Request for Proposal (RFP)

Bid No: 22-05-2798LE

Addendum No. 1

Project Name: N35(8)1,2&4 Road Improvement Project in Sweetwater, AZ

**TYPICAL CROSS SECTION
& GENERAL NOTES**

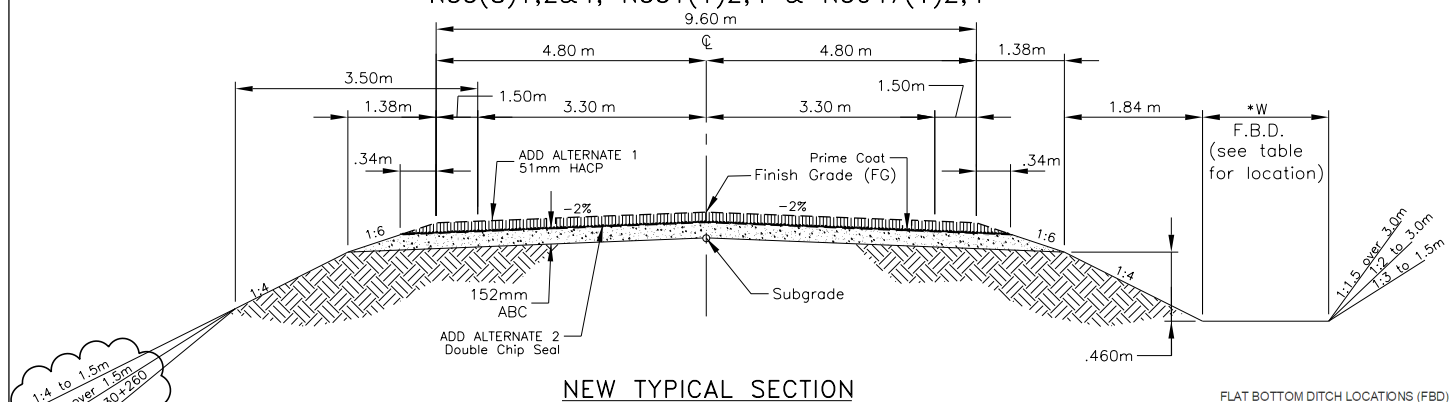
Q2: Note 16 under the General Notes section on sheet 2 mentions bid items 20401-0000 and 20403-0000. On the bid schedule there is not a bid item for 20403-0000. Should there be a bid item for 20403-0000?
